Form 3160-5
(June 2019)UNITED STATES
DEPARTMENT OF THE INTERIOR
BUREAU OF LAND MANAGEMENTFORM APPROVED
OMB No. 1004-0137
Expires: October 31, 2021**SUNDRY NOTICES AND REPORTS ON WELLS**
Do not use this form for proposals to drill or to re-enter an abandoned well. Use Form 3160-3 (APD) for such proposals.

8. Well Name and No.
MIDNIGHT HOUR 11 FED COM/723H

EOG respectfully requests an amendment to our approved APD for this well to reflect the following changes:

Revised Permit Information 04/29/2022:

WELL LOCATION AND ACREAGE DEDICATION PLAT

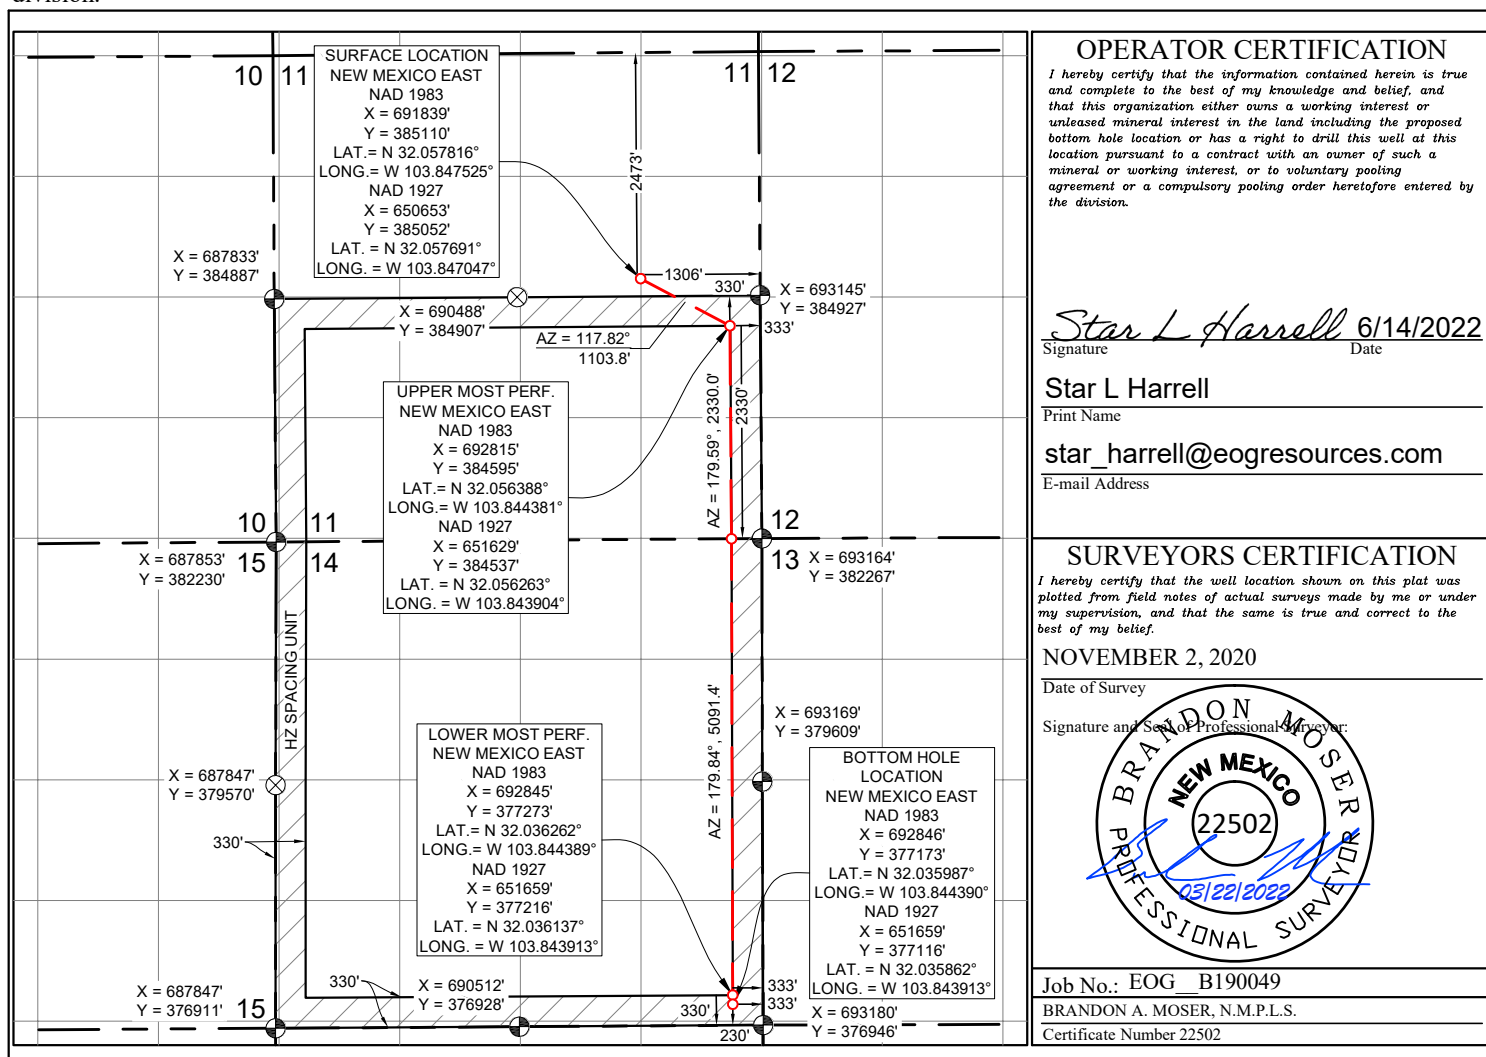
Change SHL from T-26-S, R-30-E, Sec 11, 2507' FNL, 696' FEL, Eddy Co., NM,
to T-26-S, R-30-E, Sec 11, 2473' FNL, 1306' FEL, Eddy Co., N.M.

UL or lot no.	Section	Township	Range	Lot Idn	Feet from the	North/South line	Feet from the	East/West line	County
H	11	26 S	30 E		2473	NORTH	1306	EAST	EDDY

UL or lot no.	Section	Township	Range	Lot Idn	Feet from the	North/South line	Feet from the	East/West line	County
P	14	26 S	30 E		230	SOUTH	333	EAST	EDDY
